**B.7.3 Traffic Information Response & Road Impact Assessment  
(Incorporating Traffic Impact Assessment, Pavement Impact  
Assessment & Road Safety Assessment)**

**SCENIC RIM AGRICULTURAL INDUSTRIAL PRECINCT  
RESPONSE TO COORDINATOR GENERAL'S INFORMATION REQUEST**

This letter has been prepared to respond to the Coordinator General's Request for Information (RFI) issued for the project.

With respect to traffic impacts, the items were raised by Scenic Rim Regional Council (SRRC), the Department of Transport and Main Roads (TMR) and Green Grow Pty Ltd. Table 1-1 summarises the traffic related items raised in the RFI.

CAD File: G:\510357 - Kalfresh Agricultural Industrial\6\_A\CAD\510357 Kalfresh Agricultural Industrial\TIA\_2020\_02\_13.dwg  
Imagery supplied by nearmap, February 2020

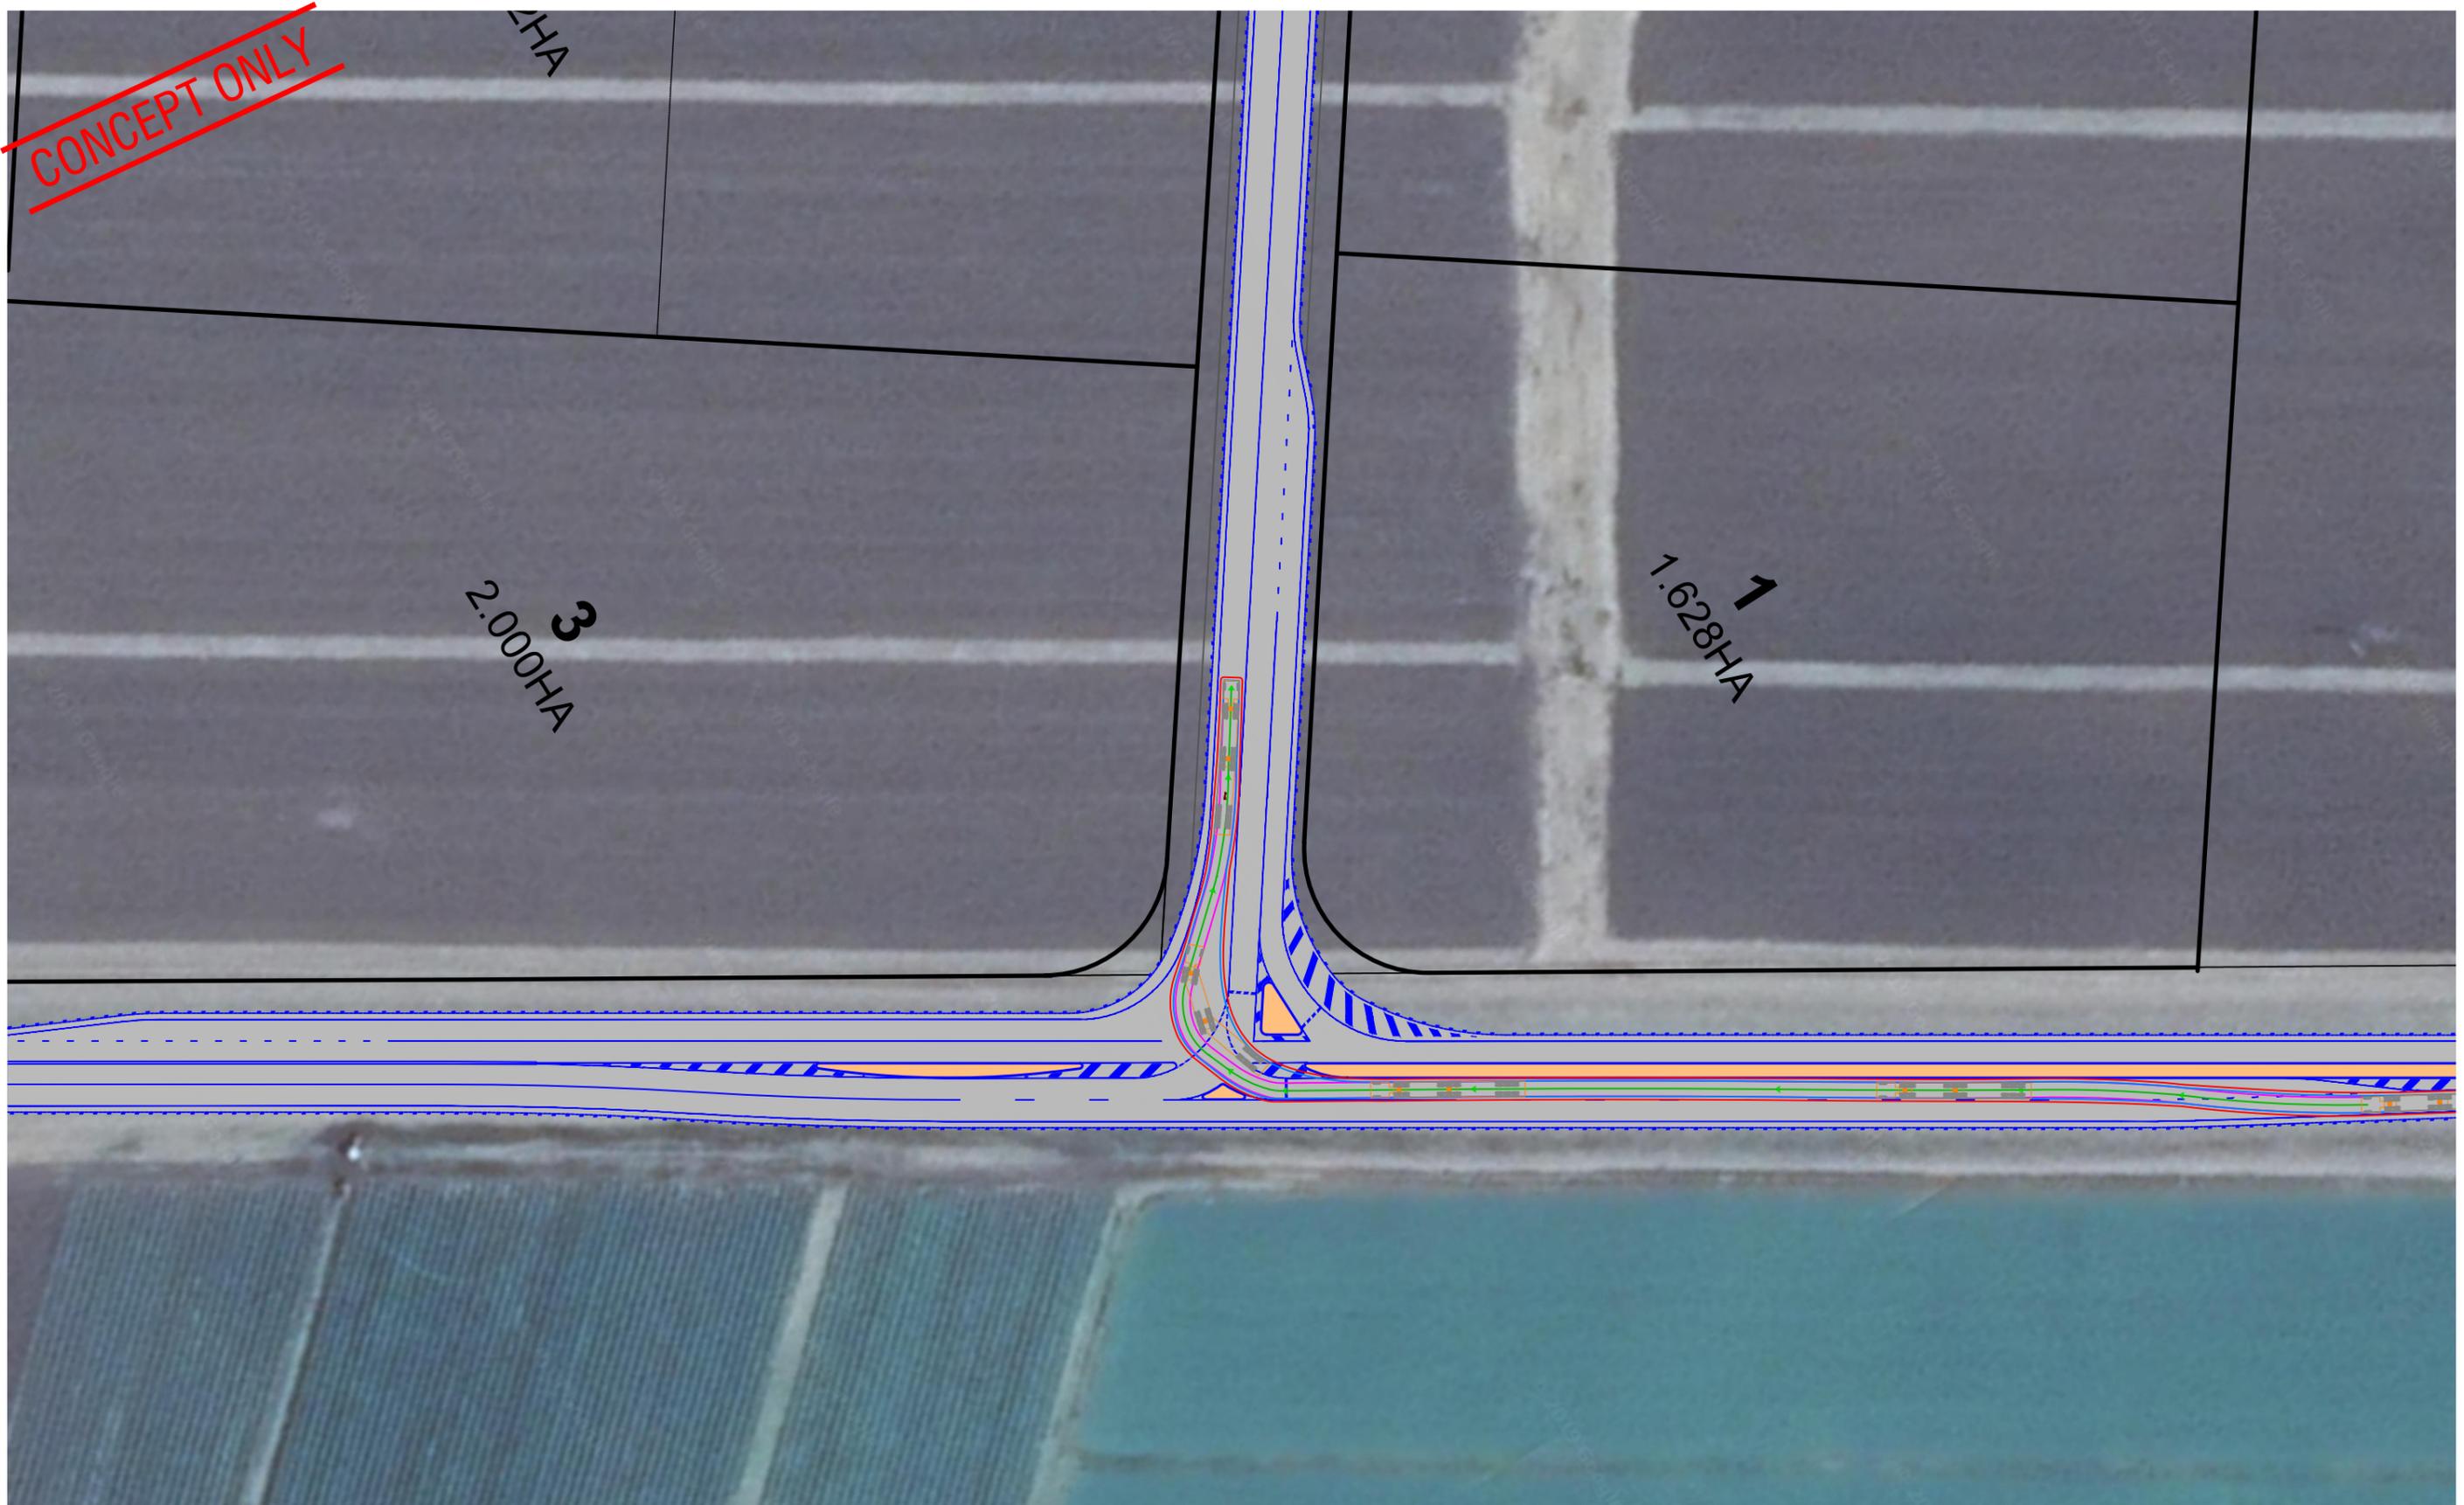
*TIA doesn't address turning movements at new intersection for largest anticipated vehicle based on 22m pavement (parking lanes). Review TIA assessment to confirm.*

The design of the new access intersection on the Cunningham Highway has been based on the swept path movement of the design service vehicle, being a B-double. The swept path drawings 510357 – SK07-SK10 enclosed at **Appendix 2** demonstrate the suitability of the intersection design.
